SUNDRY NOTICES AND REPORTS ON WELLS
 Do not use this form for proposals to drill or to re-enter an abandoned well. Use form 3160-3 (APD) for such proposals.

1. Type of Well <input checked="" type="checkbox"/> Oil Well <input type="checkbox"/> Gas Well <input type="checkbox"/> Other	8. Well Name and No. PURE GOLD D FED 4
2. Name of Operator OXY USA INCORPORATED Contact: DAVID STEWART E-Mail: david_stewart@oxy.com	9. API Well No. 30-015-27131-00-S1
3a. Address 5 GREENWAY PLAZA SUITE 110 HOUSTON, TX 77046-0521	10. Field and Pool or Exploratory Area SAND DUNES
3b. Phone No. (include area code) Ph: 432.685.5717	11. County or Parish, State EDDY COUNTY, NM
4. Location of Well (Footage, Sec., T., R., M., or Survey Description) Sec 28 T23S R31E SWSW 330FSL 330FWL

OXY USA Inc. - Current
Pure Gold D Federal #4
API No. 30-015-27131

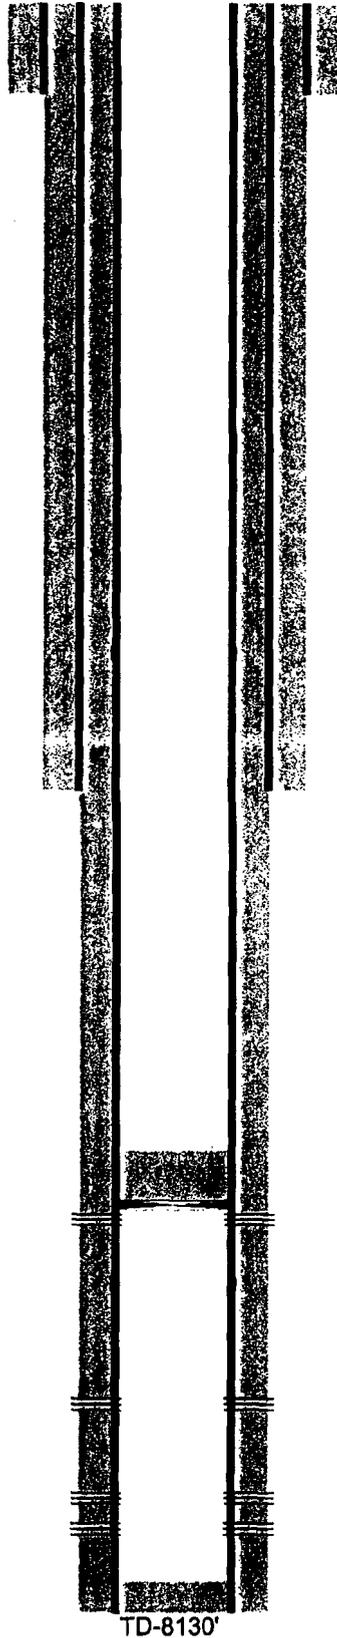
OXY USA Inc respectfully requests an extension to the temporarily abandon status. OXY is currently working towards implementing a pilot water flood nine spot pattern, and the Pure Gold D Federal #1 is located just outside of the proposed pilot. Depending on the success of the response, OXY will likely expand the flood throughout the entire field which would include this well.

This well has not produced since 09/2014. Last extension 6 months only

Approved for a period of 6 months ending 08/12/2017 subject to conditions of approval.

1. Well is approved to be TA/SI for a period of 12 months or until 08/12/2017
2. This will be the last TA approval for this well.
3. Must submit NOI to recomplete or NOI to P&A. Must be submitted by 08/12/2017
4. COA's met at this time.
